## Proposed Filing - Coversheet

**Vermont Commercial Building Energy Standards (CBES)**

**Amendments**

**FIGURE C405.2.4.2(1)**  
**PRIMARY AND SECONDARY SIDELIT DAYLIGHT ZONES**

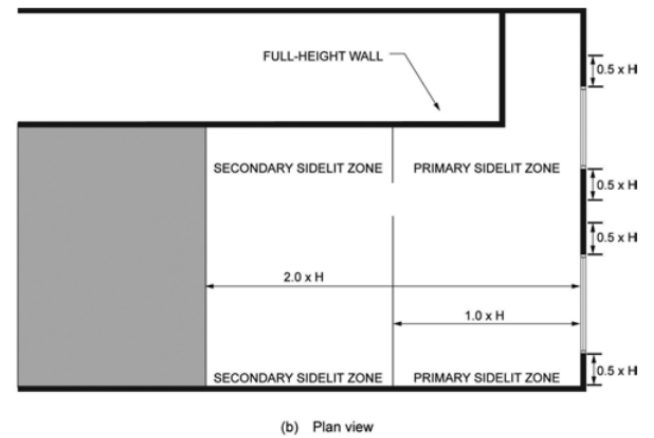
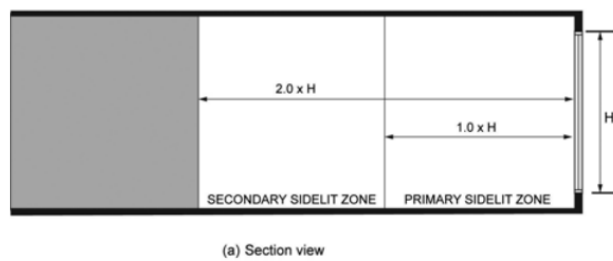
~~delete C405.2.3.2 Sidelit daylight zone~~ and replace with **C405.2.4.2 Sidelit daylight zone**

1. Where the fenestration is located in a wall, the sidelit daylight zone shall extend laterally to the nearest full-height wall, or up to 1.0 times the height from the floor to the top of the fenestration, and longitudinally from the edge of the fenestration to the nearest full-height wall, or up to 0.5 times the height from the floor to the top of the fenestration, whichever is less, as indicated in Figure C405.2.4.2(1).
2. Where the fenestration is located in a rooftop monitor, the sidelit daylight zone shall extend laterally to the nearest obstruction that is taller than 0.7 times the ceiling height, or up to 1.0 times the height from the floor to the bottom of the fenestration, whichever is less, and longitudinally from the edge of the fenestration to the nearest obstruction that is taller than 0.7 times the ceiling

3. The secondary sidelit daylight zone is directly adjacent to the primary sidelit daylight zone and shall extend laterally to 2.0 times the height from the floor to the top of the fenestration or to the nearest full height wall, whichever is less, and longitudinally from the edge of the fenestration to the nearest full height wall, or up to 2 feet, whichever is less, as indicated in Figure C405.2.4.2(1). The area of secondary sidelit zones shall not be considered in the calculation of the daylight zones in Section C402.4.1.1.

**FIGURE C405.2.4.3  
TOPLIT DAYLIGHT ZONE**

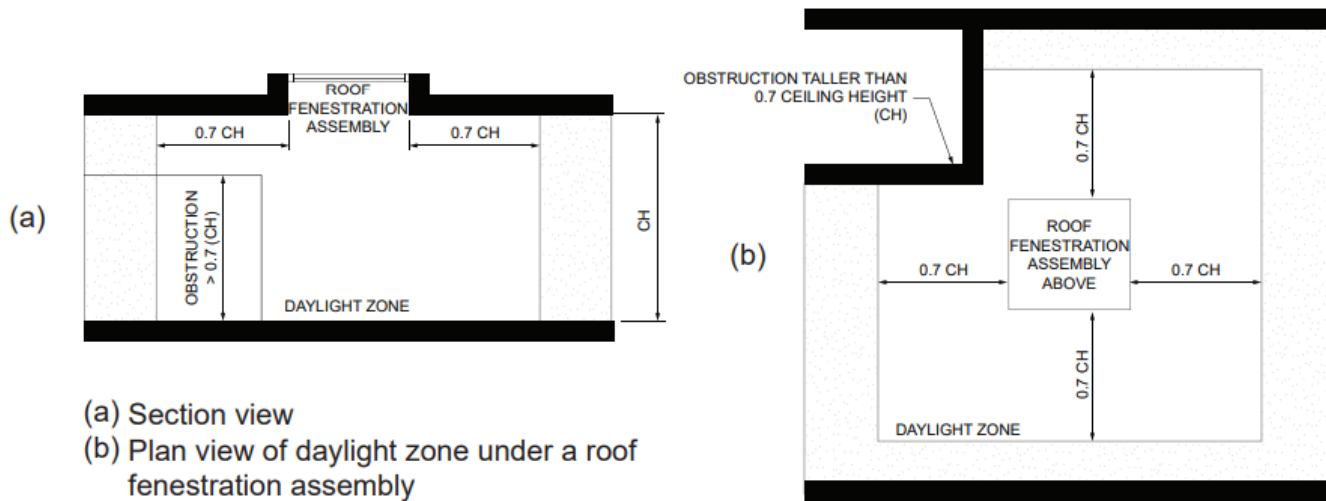
**Delete C405.2.3.3 Toplit zone and replace with C405.2.4.3 Toplit daylight zone**

1. The *toplit daylight zone* shall extend laterally and longitudinally beyond the edge of the roof fenestration assembly to the nearest obstruction that is taller than 0.7 times the ceiling height, or up to 0.7 times the ceiling height, whichever is less, as indicated in Figure C405.2.4.3.
2. Direct sunlight is not blocked from hitting the roof fenestration assembly at the peak solar angle on the summer solstice by buildings or geological formations.
3. The product of the visible transmittance of the roof fenestration assembly and the area of the rough opening of the roof fenestration assembly divided by the area of the *toplit* zone is not less than 0.008.
4. Where toplit daylight zones overlap with sidelight daylight zones, lights within the overlapping area shall be assigned to the toplit daylight zone.

**FIGURE C405.2.4.4  
DAYLIGHT ZONES AT A MULTISTORY ATRIUM**

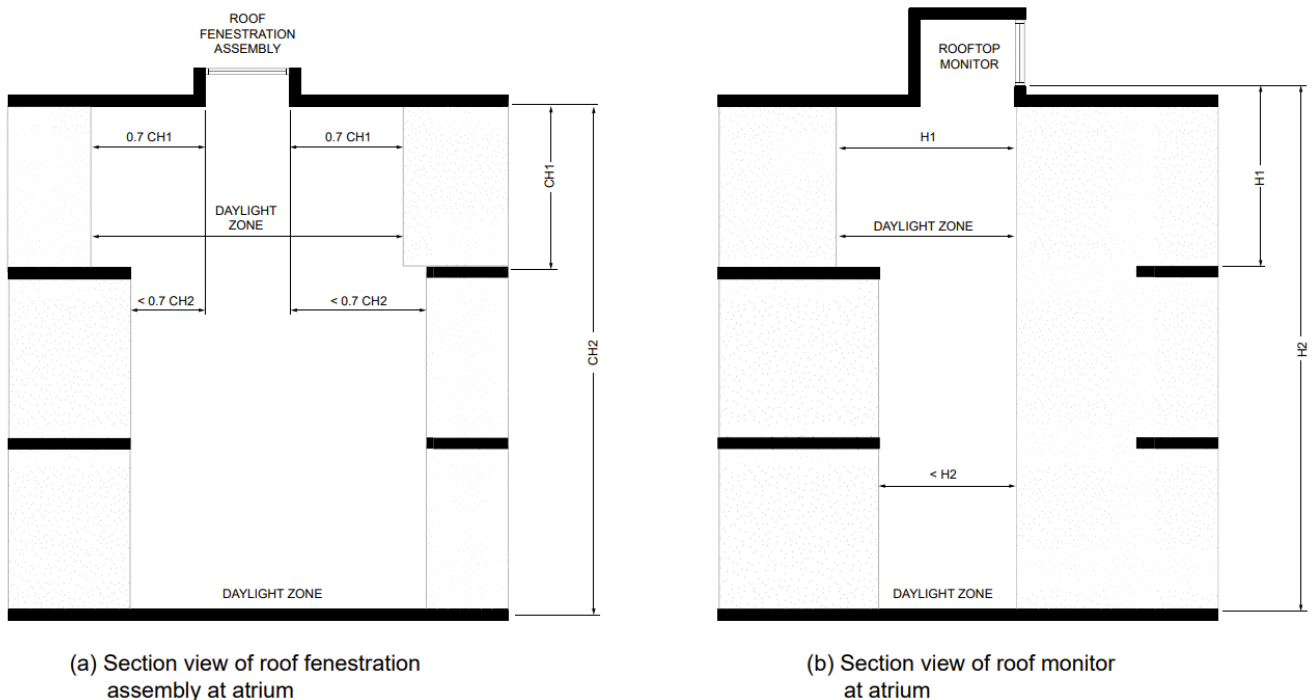
**add C405.2.4.4 Atriums.** Daylight zones at atrium spaces shall be established at the top floor surrounding the atrium and at the floor of the atrium space, and not on intermediate floors, as indicated in Figure C405.2.4.4.

**FIGURE C405.2.4.2(1)**  
**PRIMARY AND SECONDARY SIDELIT DAYLIGHT ZONES**

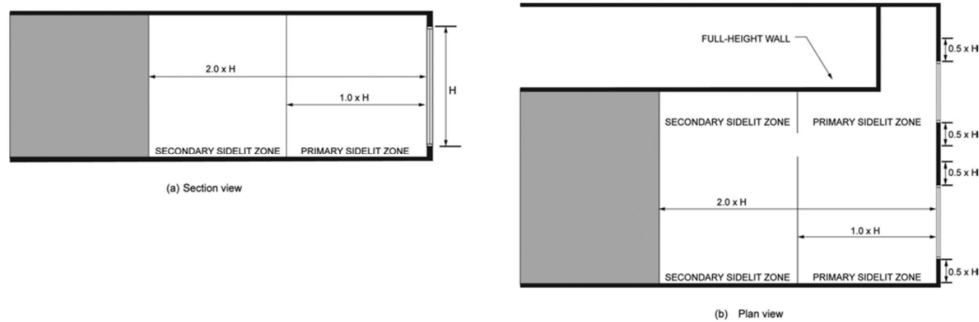
~~8. 10. In parking garages with floor area adjacent to perimeter wall openings, the daylight zone shall include the area within 20 feet of any portion of a perimeter wall that has a net opening to wall ratio of at least 40 percent.~~

~~-delete and replace-~~

**FIGURE C405.2.4.3(4)**

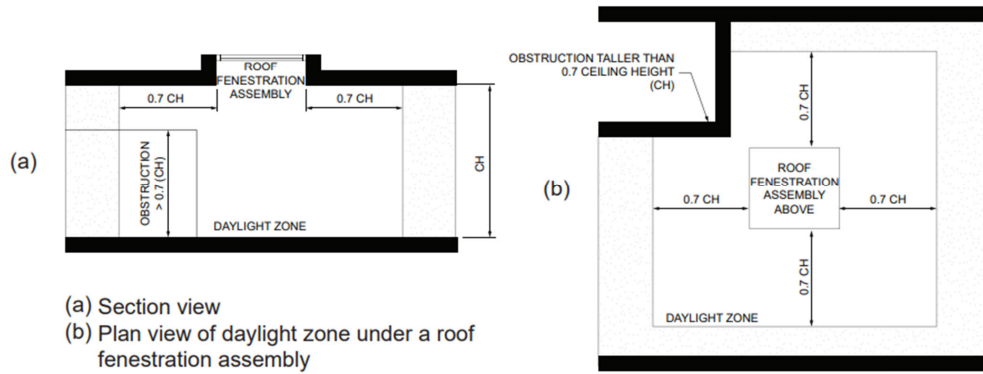
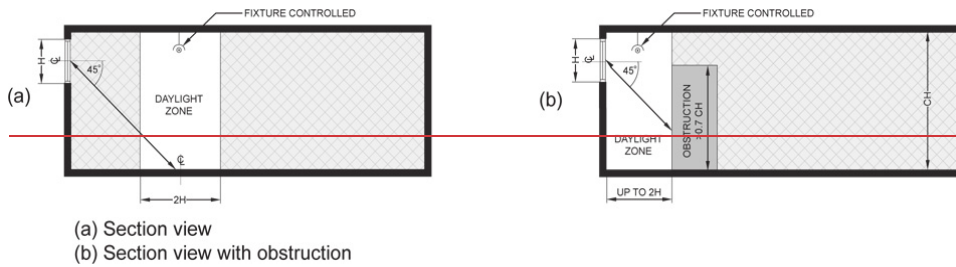
~~5.~~ 4. Where toplit daylight zones overlap with sidelight daylight zones, lights within the overlapping area shall be assigned to the toplit daylight zone.

~~add~~
